CITY PLANNING COMMISSION

- APPLICATION:
1. Environmental Determination
 2. Amendment of the Valley Hi Community Plan from Light Density Residential to Medium Density Residential
 3. Rezone 12± acres from Single Family (R-1) to Medium Density Multiple Family (R-3)
 4. Special Permit to develop condominium units

APPLC. NO. P83-334

MEETING DATE January 12, 1984

Exhibit "K-1"

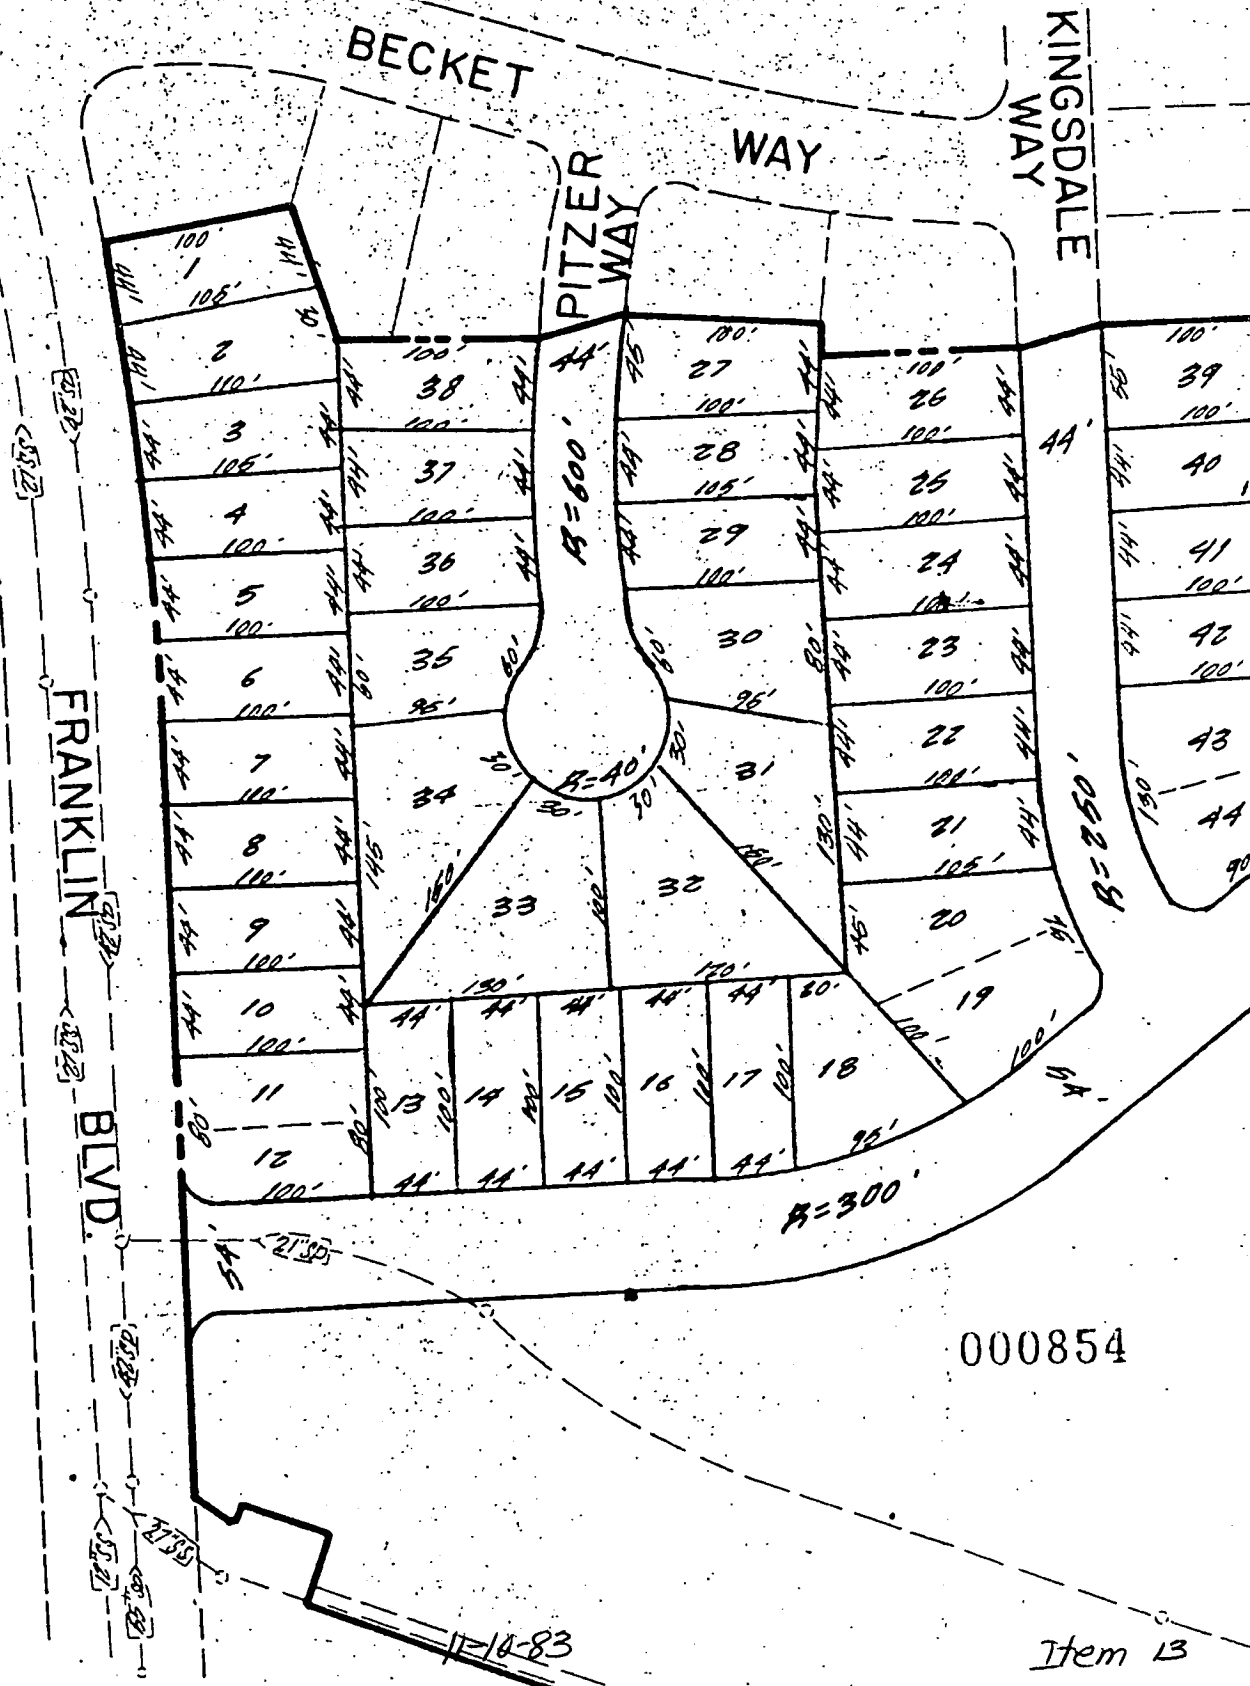
3. The subdivision map has been designed with ten front-on lots on Franklin Boulevard which is a designated major street (see exhibit K-1). Staff recommends that this design be revised per exhibit K-2. This revision reduces the number of front-on lots from ten to two and provides for an increase in lot width to 75± feet for the remaining two lots. The intent of this redesign is to eliminate back out maneuvering onto Franklin Boulevard and to provide for access directly onto side streets as much as possible. The indicated halfplex lots will access onto the side streets. The interior single family lots are of sufficient width to accommodate circular driveways or other similar design features to eliminate potential backout problems onto Franklin Boulevard.

- o. Place the following note on the final map: The existing drainage line located within Lot A shall be located under paved areas or other areas as permitted by the City Public Works Director. In no event shall structures be permitted over this line.
- p. Revise the lotting pattern and street design per exhibit K-2 or some other similar alternative acceptable to the Planning Director.

VILLA ROYALE
CONDOMINIUMS

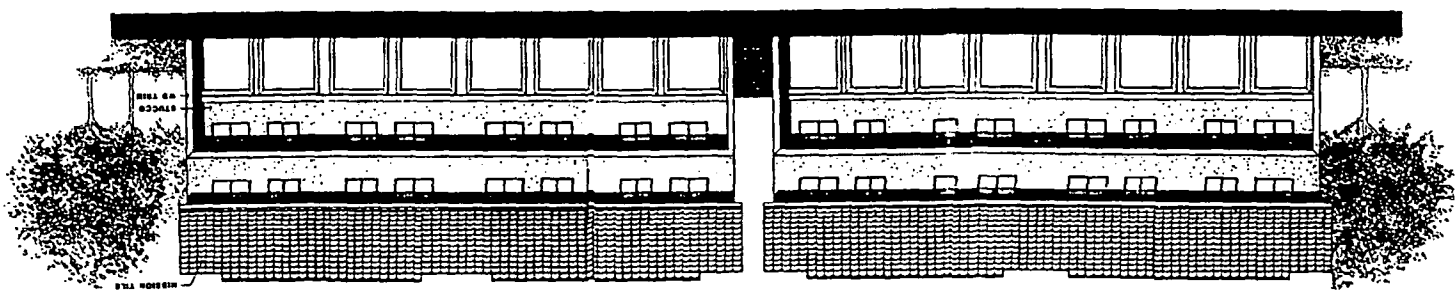
3. Subsequent to the Commission hearing on November 10, 1983 the applicant submitted the attached elevation and floor plans. Staff finds that for a project of this magnitude additional elevations and floor plans should be required. Also, only one set of elevations, indicating one side of the building, has been submitted. Staff finds it necessary to review all elevations in order to assure design consistency.
